Board of Trustees Regular Meeting Agenda Hartland Township Hall Tuesday, November 29, 2022 7:00 PM

Submitted By: Troy Langer, Planning Director

Subject: Site Plan with Special Land Use Application #22-015 (Mini warehouse establishment with outdoor storage as accessory to a permitted use)

UNLESS EXEMPT, PROJECT MUST COMPLY WITH LIGHTING CONTROLS REQUIRMENTS DEFINED IN ASHRAE 90.1 2013. FOR SPECIFIC INFORMATION CONTACT GBA CONTROLS GROUP AT ASG@GASSERBUSH.COM OR 734-266-6705.

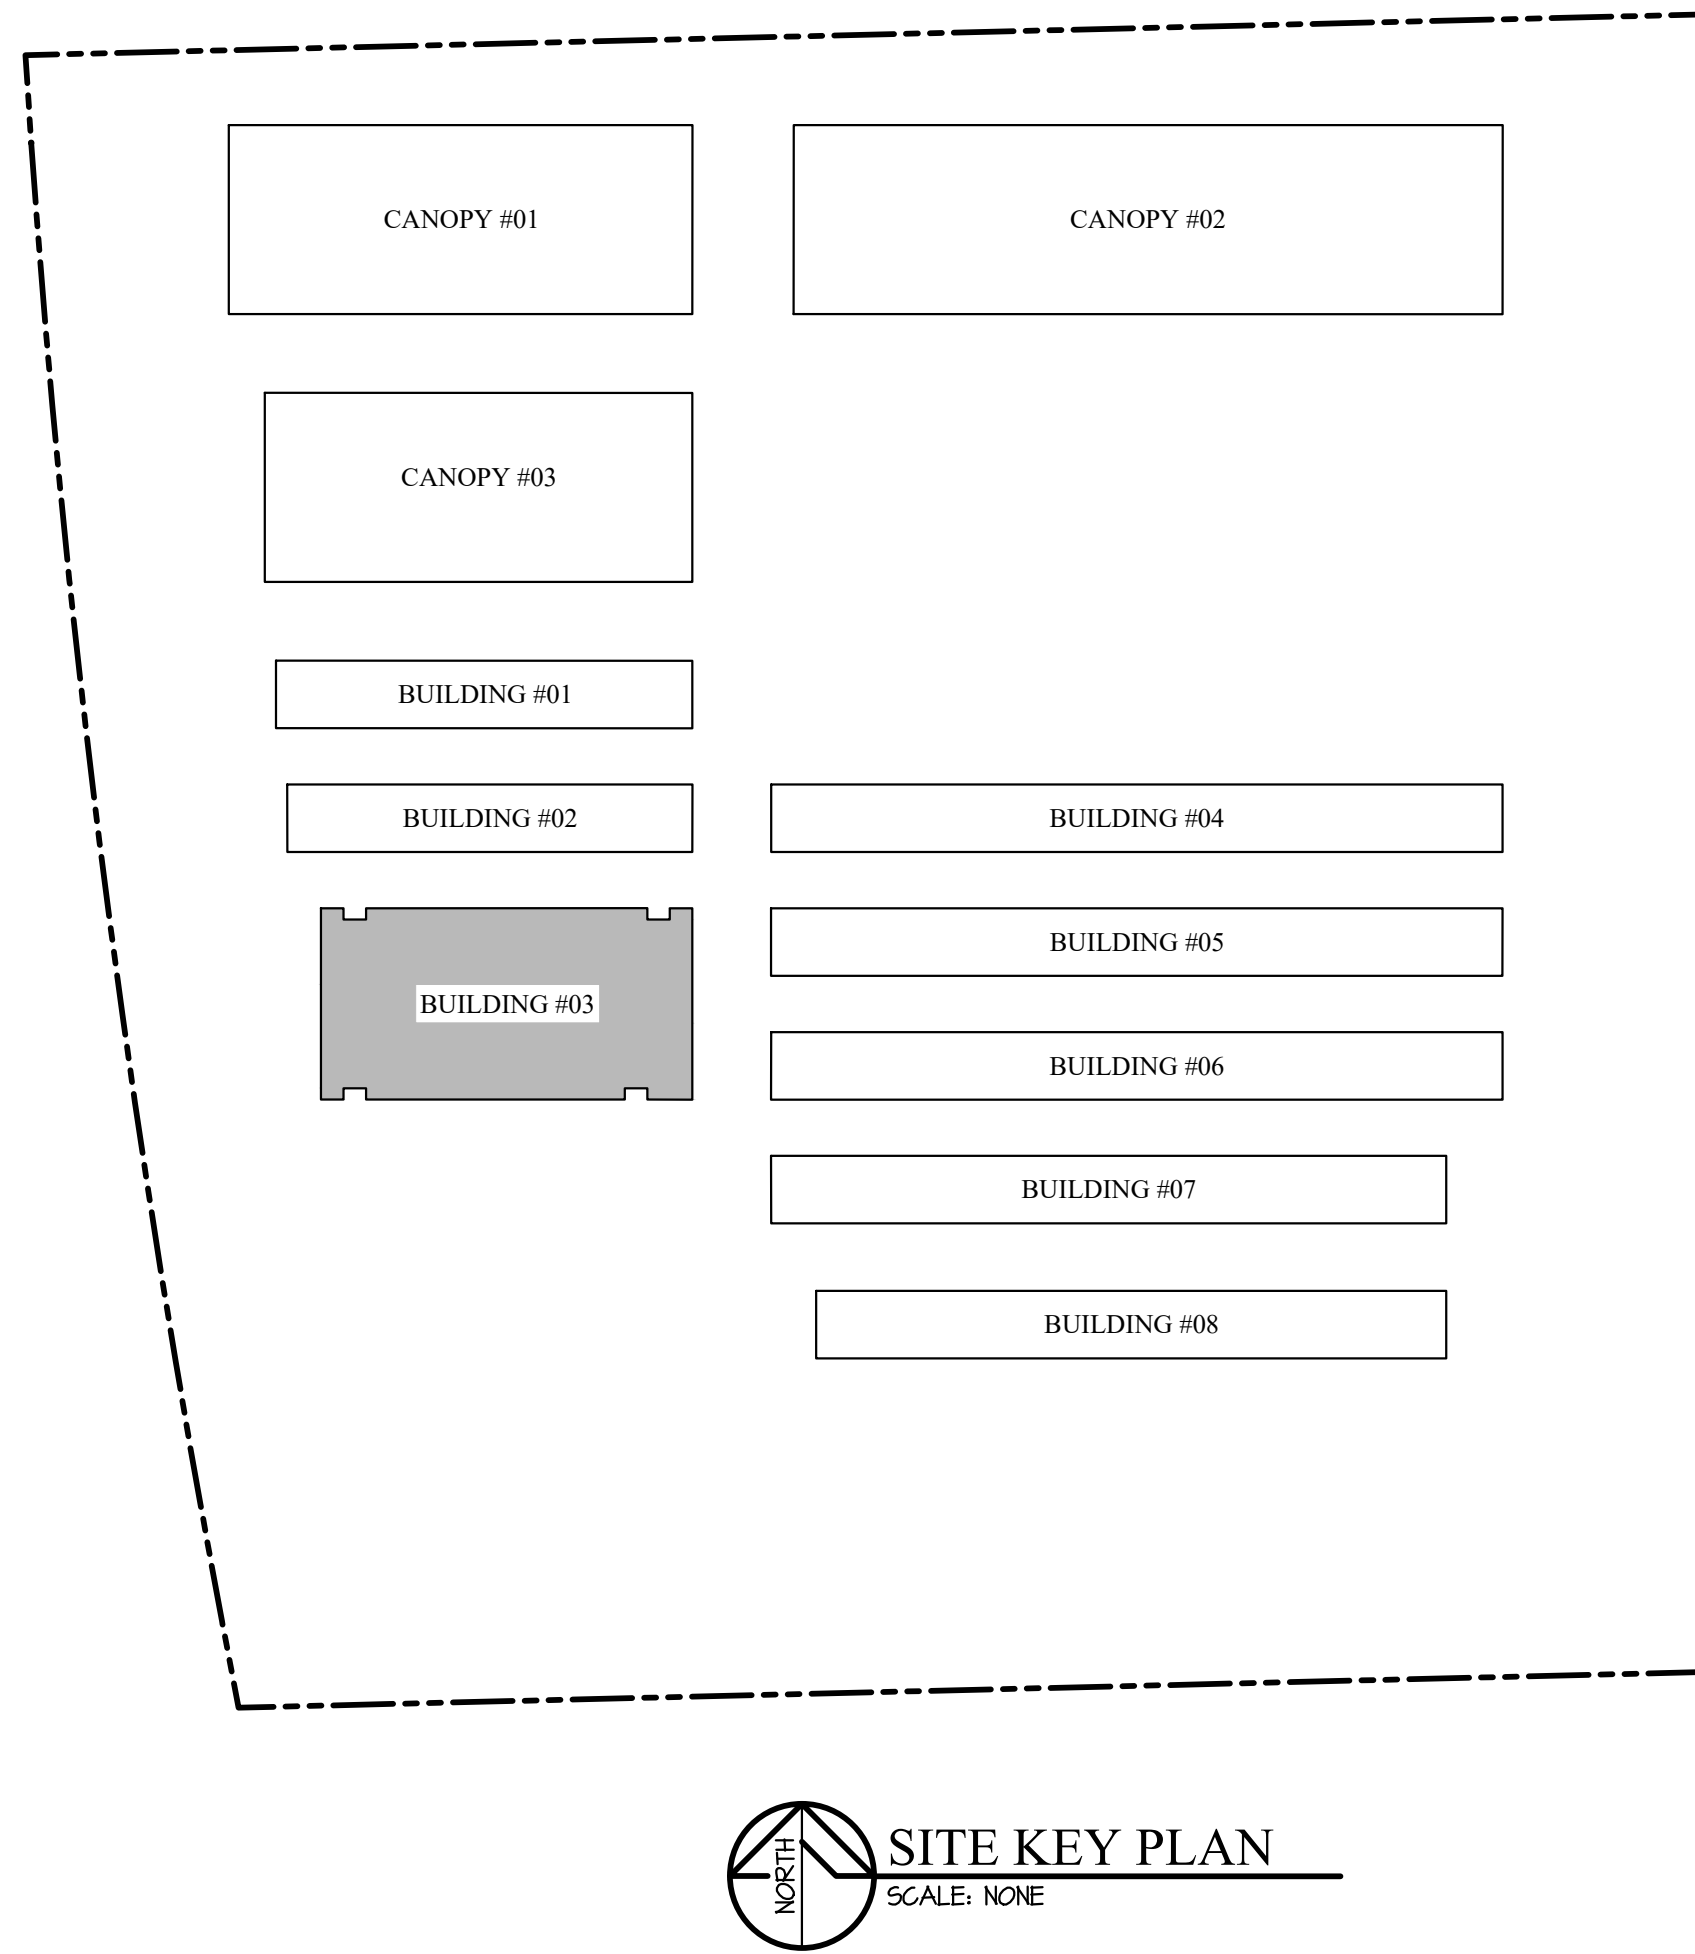
- Proposed – Photometric plan indicates 0.0 to 0.1 fc along each property line. Footcandle value less than 10 fc throughout the site. Information on average footcandle values in the main parking area, at main building entrance, and exit/entry drives was not provided. Footcandle values are measured at 0 feet above ground level and required height for measurement is 5 feet above ground level.

- Meets Requirement? – See notes below
- Comment – For this site intensity levels at the main exit/entry drive should be provided, but intensity levels at the main parking area and main building entry do not seem relevant, as there is a limited parking area and no designated main building (Building #3 at the office entrance could be of consideration). Photometric plan to be revised to measure the footcandle values at 5 feet above ground level and lighting intensity at the main exit/entry drive on the Construction Plan set.

BUILDING #04 - WEST ELEVATION

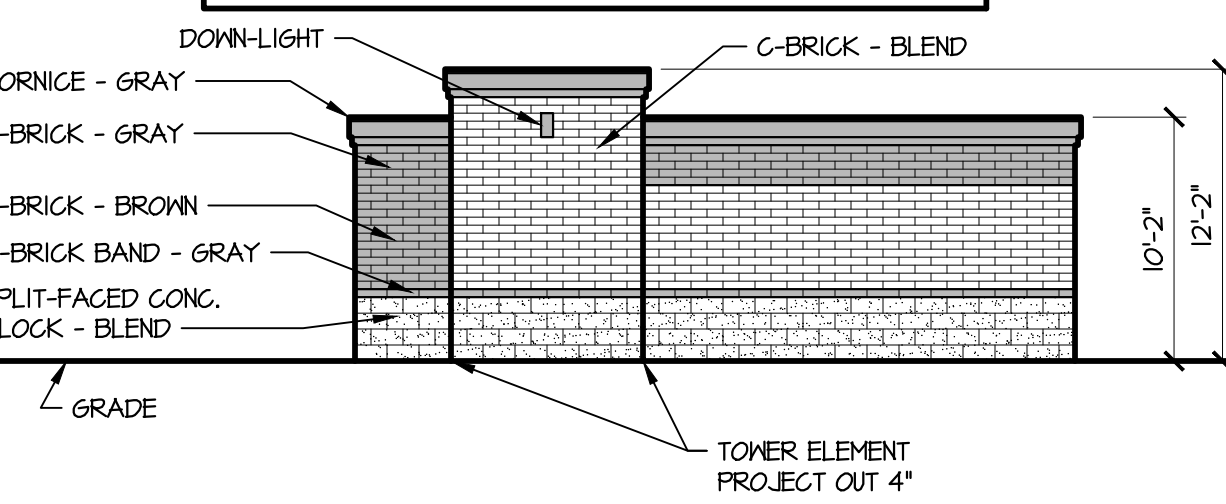
*Staff assumes the information listed for Building #4 on Sheet A2 has flipped the façade material information for the east and west end walls, as the east end wall faces US-23 and would have masonry products, and the west end wall is interior to the site and may have 1-3 garage doors/ribbed metal panels.
